ENGINEERING CHANGE PROPOSAL (ECP), PAGE 1				1. DATE (YYYYMMDD) 20020828		Form Approved OMB No. 0704-0188			
The public reporting burden for this collection of information is estimated to average 2 hours per response, including the time for reviewing instructions, searching existing data sources, gathering and maintaining the data needed, and completing and reviewing the collection of information. Send comments regarding this burden estimate or any other aspect of this collection of information, including suggestions for reducing the burden, to Department of Defense, Washington Headquarters Services, Directorate for Information Operations and Reports (0704-0188), 1215 Jefferson Davis Highway, Suite 1204, Arlington, VA 22202-4302. Respondents should be aware that notwithstanding any other provision of law, no person shall be subject to any penalty for failing to comply with a collection of information if it does not display a currently valid OMB control number. PLEASE DO NOT RETURN YOUR COMPLETED FORM TO THIS ADDRESS. RETURN COMPLETED FORM TO THE GOVERNMENT ISSUING CONTRACTING OFFICER FOR THE CONTRACT/PROCURING ACTIVITY NUMBER LISTED IN ITEM 2 OF THIS FORM.						2. PROCURING ACTIVIT

Figure 2 - 90% Spheroidization (minimum)

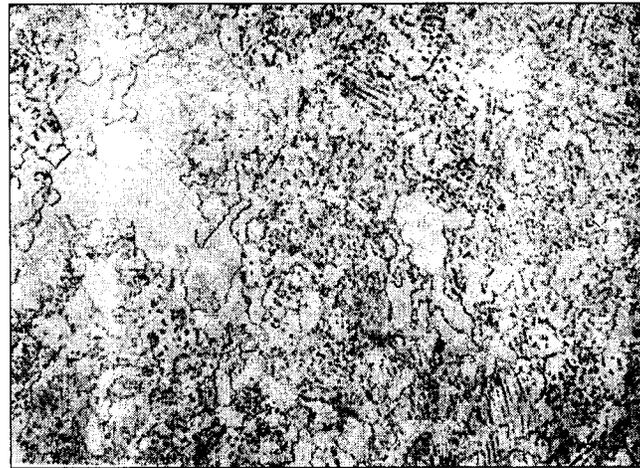
11. ECP NO. R2J2024			
12. CONFIGURATION ITEM (OR SYSTEM) TO WHICH ECP APPLIES Body, 60mm, HE, M720 or M888			
13. DESCRIPTION OF REVISION Delete paragraphs 1 through 6 and Figures 2, 3, and 4 in their entirety and substitute the following new paragraphs 1 through 6 and Figures 1, 2, and 3. See attached.

3.3.1 Micro-structure test. The projectile shall be sectioned and microstructure specimen shall meet the minimum of 90% spheroidization that is comparable to the degree of spheroidization depicted in Figure 2.

4.4.3.1.3.1 Heat treatment batch. The samples selected in accordance to 4.4.3.1.2 shall be tested to determine the degree of spheroidization. Failure of the specimen to exhibit the degree of spheroidization depicted in the standard (see Figure 2) shall be cause for rejection of the heat treatment batch when tested as specified in 4.5.1.3. When it has been determined that the microstructure specimens comply, the furnace temperature and time shall be established and maintained throughout spheroidization operation. An advisory spheroidization cycle is 1290°F at heat for 24 hours. At no time during the process shall the critical temperature of 1300°F maximum be exceeded in any thermal treatment after spheroidization.
